## Design Team Point of View

*Item 3, 11/15/23 CHB HARRIS*  
 EXH. A: EXCERPTS CHB STAFF REPORT (12/17/1980)

RE: Nomination of the Eastside Social Services Center (the former University Heights Junior High School) to CHB Landmark Status.

EXH. I: ORIENTATION & REGULATING LINES (DESIGN CONCEPT, PRESENTATION, PP. 6, 8)

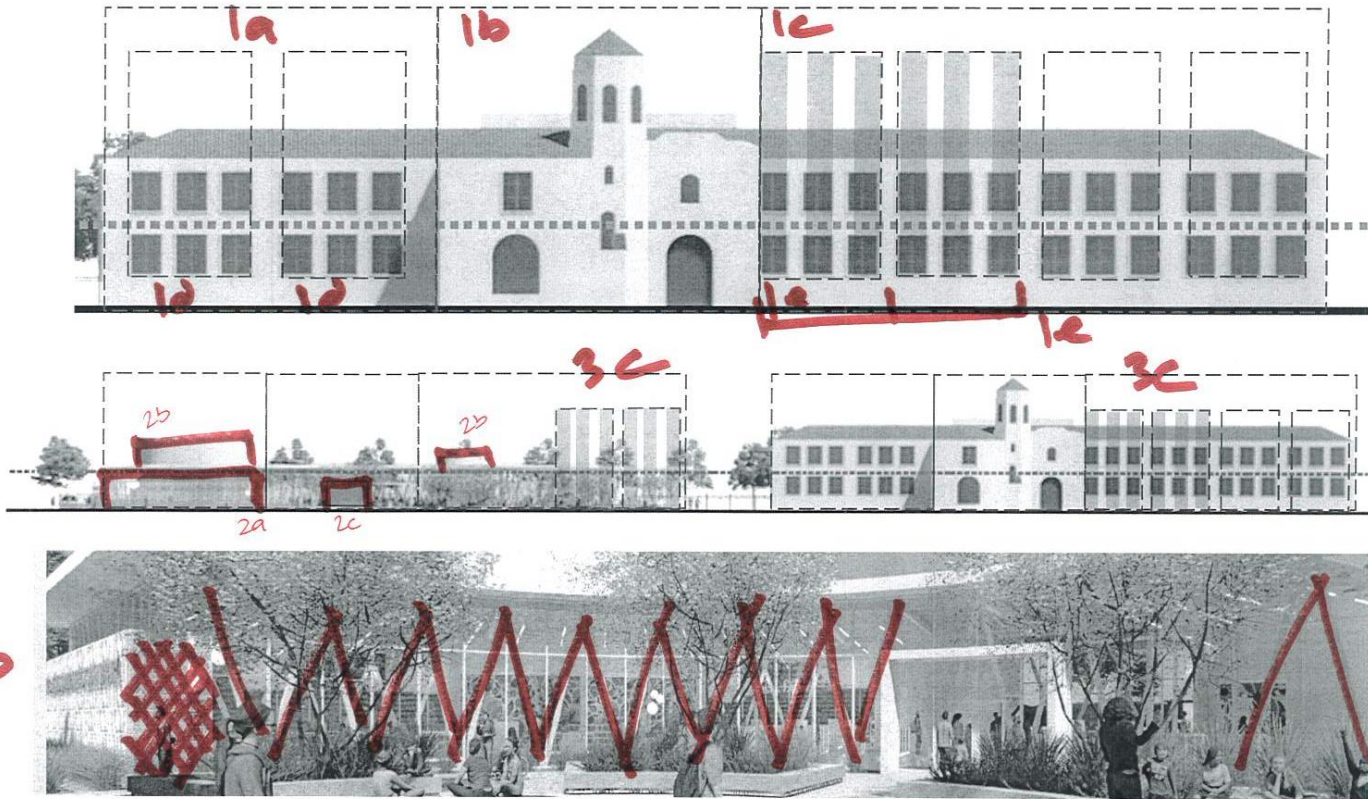
- (1) Landmark 3 main components (a) east pavilion (b) entrance (c) west pavilion with (d) consistent bays and (e) window columns
- (2) Alternatively (if not mirrored but rather matched components [as currently proposed]), suggest modifying (a) eastern frontage and (b) roof projections to better define entrance component, and (c) move main entrance to centrally locating within entrance component.
- (3) For exterior skin suggest (a) incorporating scale of bays and windows and (b) remove V-shaped support structure (seems busy, distracting, unnecessary cost, introduces seemingly new element); and (c) glazing should not distract or introduce new colors.

- 3. The V shaped columns are required seismic bracing. Rather than typical vertical columns with multiple brace frames throughout the building, the design team has merged the two into one single V that performs both the gravity and lateral function of the structure. The V columns are a major character defining element of the building design and create a lightness of the roof by eliminating the heaviness of the vertical column and extensive structural seismic bracing.

EXH. J: HORIZONTAL/HEIGHT REGULATING LINES (DESIGN CONCEPT, PRESENTATION, P. 6)

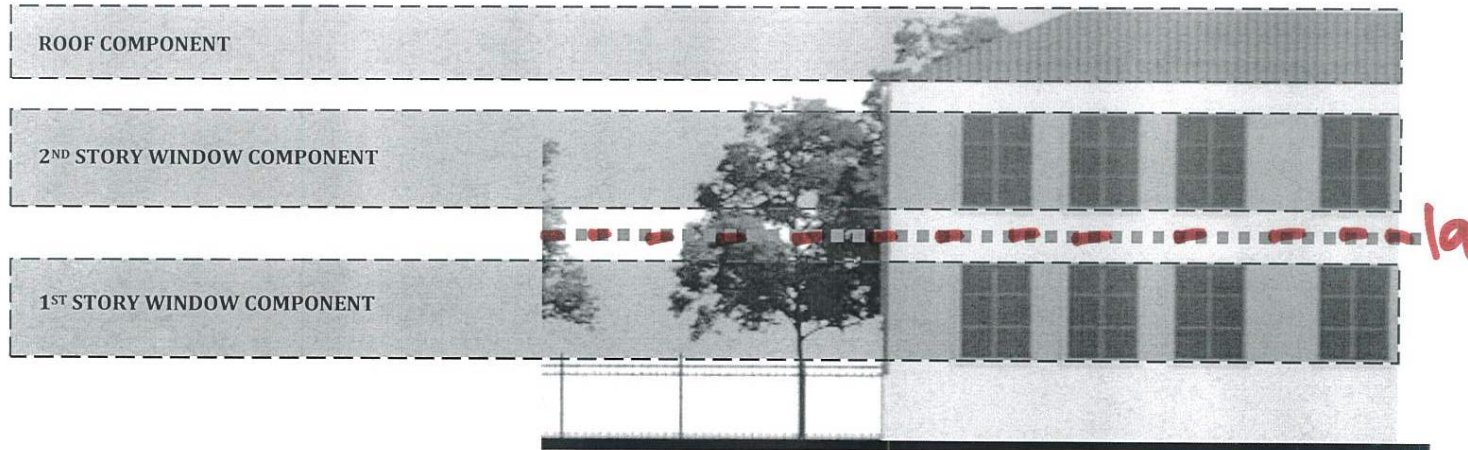
- (1) As proposed (a) roofline, (b) roof projections, (c) architrave does not match any of the regulating lines.
- (2) Increase/lower component heights and other major height lines to match regulating lines outlined above.

- 1. See response to comment 8(4) above regarding relationship between buildings and regulating lines.

EXH. K: HARDSCAPE/FLOOR SCAPE (DESIGN CONCEPT, PRESENTATION, P. 8)

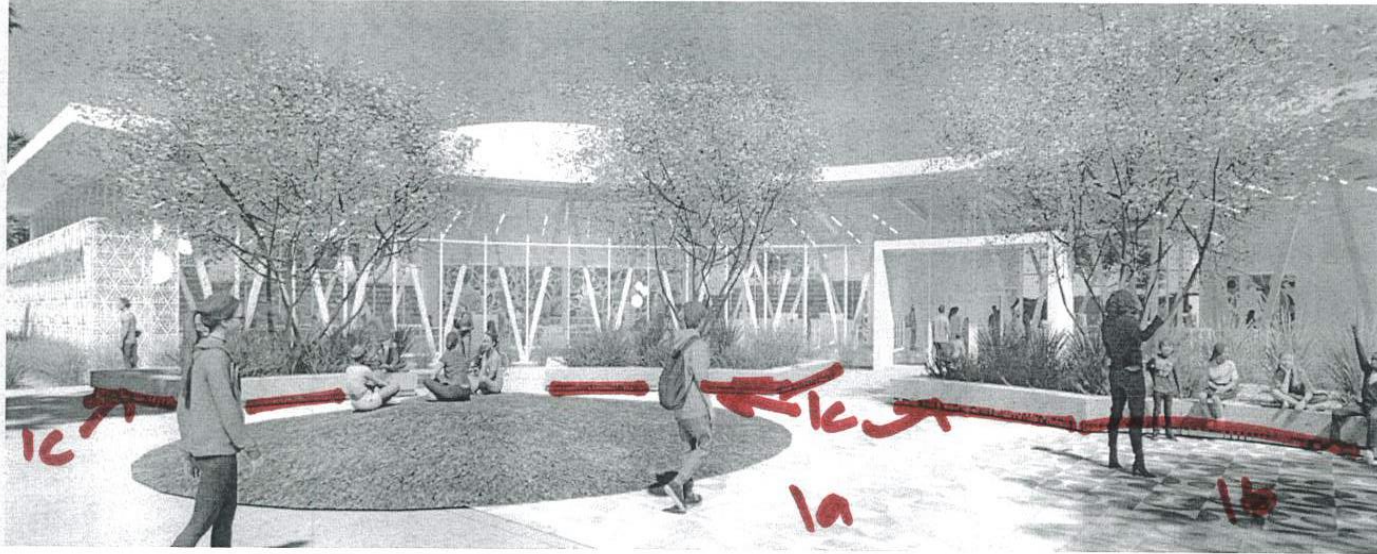
- (1) Generally (a) white, gray scale and (b) red/white tiles seems appropriate; (c) multi-color tile distracting and busy
- (2) Recommend incorporating existing/relocated trees to extent feasible
- (3) Recommend grass/permeable paver system in the front area and elsewhere (multi benefits)

1. Multicolor tile has been removed from the project and replaced with concrete shadow reveals.
2. New tree selections and locations have been made to reflect budget and passive supervision, and safety strategies.
3. A landscape plan has been submitted and includes a variety of exterior landscape surfaces.
